**LEGAL ADVERTISEMENT
HISTORIC PRESERVATION BOARD
CITY OF PORTLAND
Public comments are taken at all meetings.**

CITY OF PORTLAND, MAINE
HISTORIC PRESERVATION BOARD

**PUBLIC HEARING
164 MIDDLE STREET**

RE: February 1, 2017 **Public Hearing** – Amendment to Approved Plans
(Entry canopies and signage program)

E9 ILLUMINATED BLADE SIGN
1/2"=1'-0"

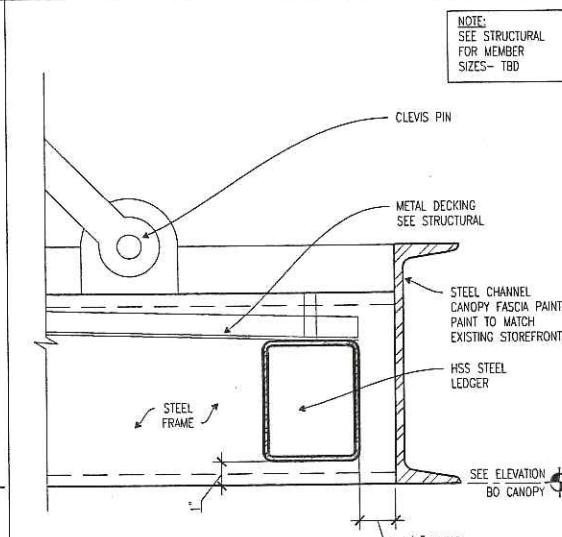
Blade sign at northwest corner – Middle Street façade: This vertically oriented blade sign would replace the awkwardly shaped White Cap Grill sign that projected at a 45 degree angle from the corner of the building. As proposed, the sign is at a right angle to the Middle Street face and the street.

- Individual white letters are proposed to stand out from the black box of the sign, and the letters would be internally illuminated. Staff suggests that if the Board finds this form of illumination appropriate for the context, there might be limits placed on the brightness of the letters.
- The proposed location of the sign is higher than the previous sign – the architect suggests this will avoid straddling the cornice at the top of the storefront, which might compete with or partially obscure the iron details of the ground floor.
- While the proposed location is higher than the generally accepted level for blade signs which would normally specify that the sign be attached below second floor window sills, the Sign Guidelines allow for exceptions:

TRIANGLE SIGN & SERVICE
D/F CANVAS BLADE SIGN W/ BRACKETS | ELEVATION
Scale: 1/2" = 1'-0"
QTY. REQ'D: ONE (1)
15.17 SQ. FT.

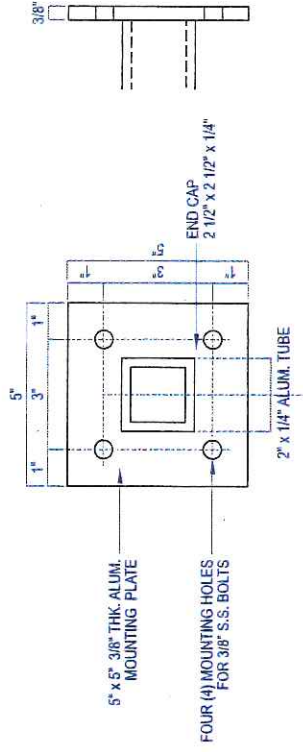
Market Street Banners: Two canvas West Elm signs are proposed for Market Street, with a third canvas sign possible when the lower retail space at the far, lower end of the building has a tenant.

- Staff questions whether two canvas signs are justified (see Standards Section F., below.)
- The previous owner of the property displayed a number of banners on Market Street, which the Board urged be removed. While the current proposal recalls those banners, this proposal is to be reviewed as a new sign application.

PATIO
PERSPECTIVES

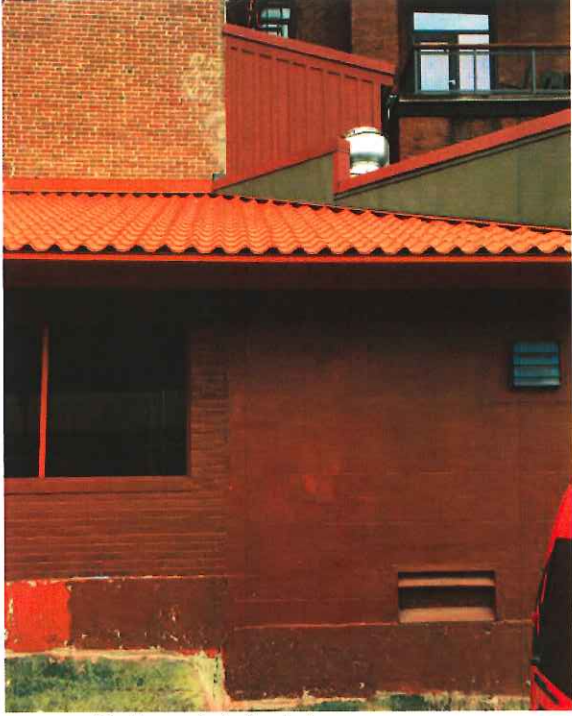
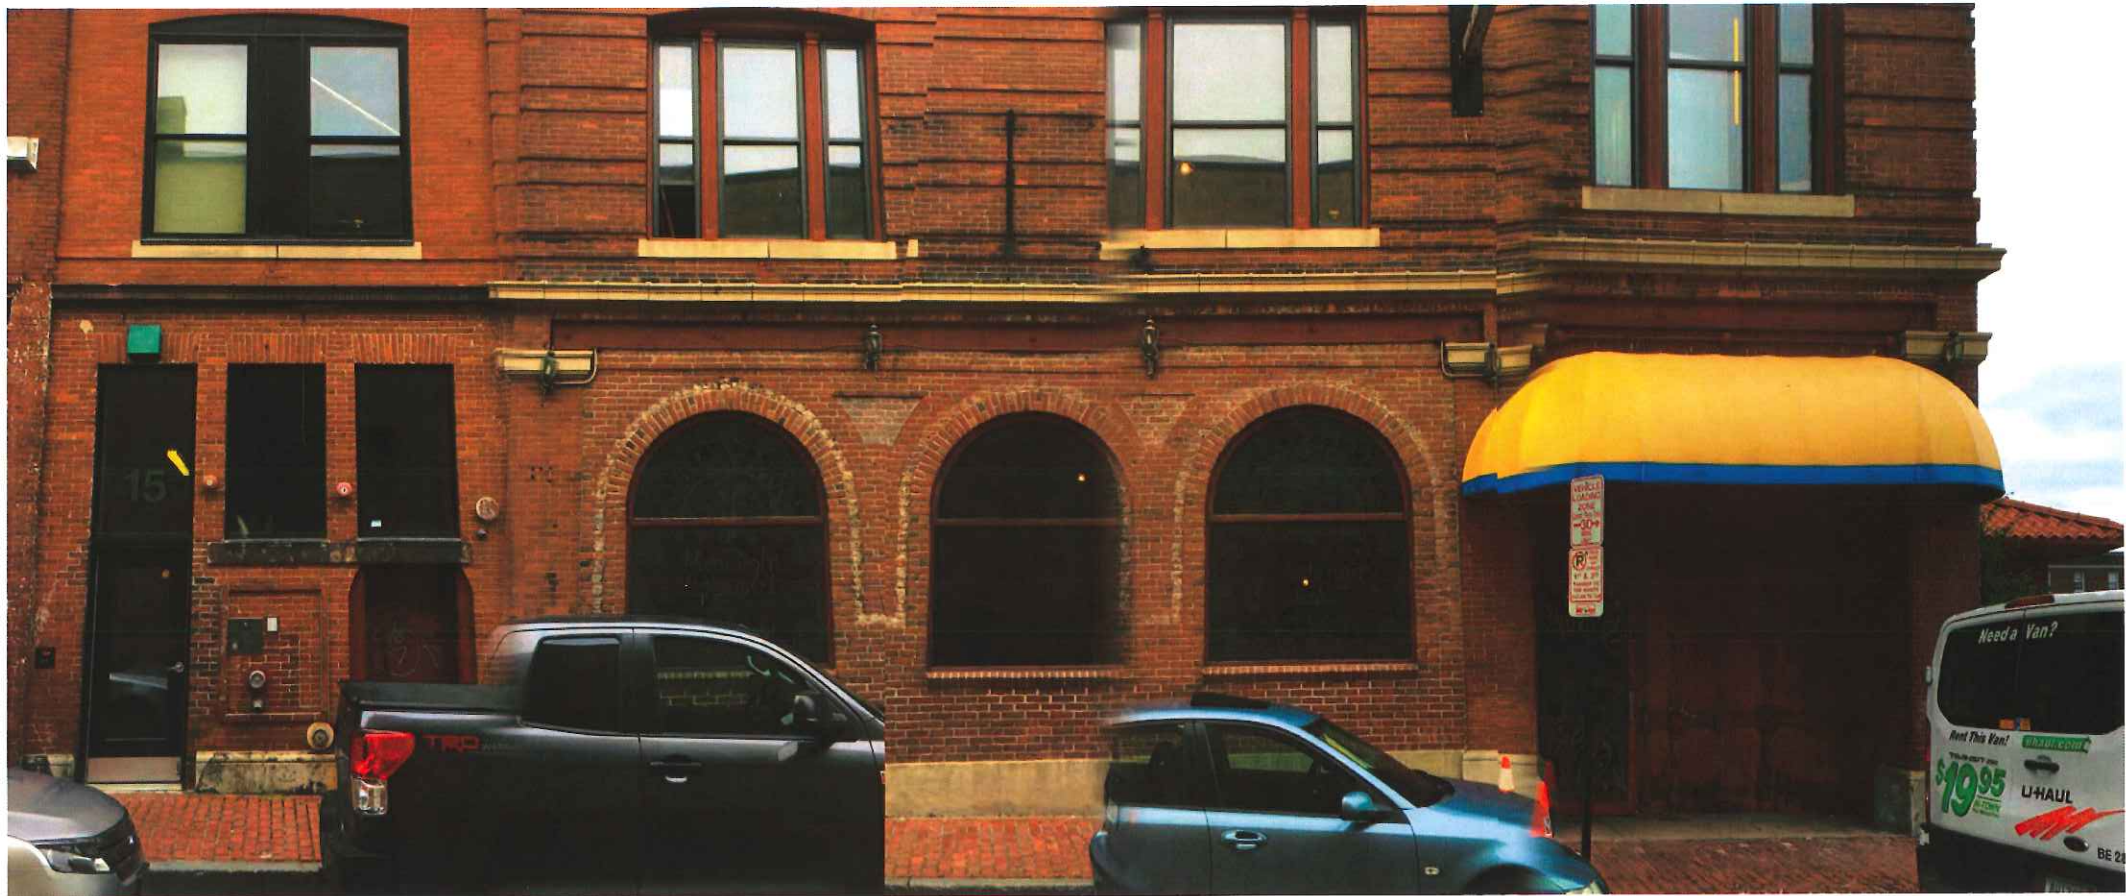
Several Board members questioned the use of painted board-and-batten siding for the rear kitchen block, despite its presence on an existing second-floor rear shed. A dull, brick red was endorsed as a color, but the material itself was suggested to be rustic and inappropriate – not in keeping with the urban context and other hard materials in use close by. One suggestion was that painted CMU like the existing wall would be more appropriate than the proposed painted board-and-batten.

Staff also has several questions regarding the proposal of fiber cement panels to cover the walls of the rear kitchen block.

Mr. Broadbent provided a summary the revisions included in the final plans - see Attachment 1. With the exception of the new wall covering – fiber cement panels - for the front and side of the kitchen block, plans for the beer garden, corten screen, and rear block are essentially unchanged since the January 4 submission.
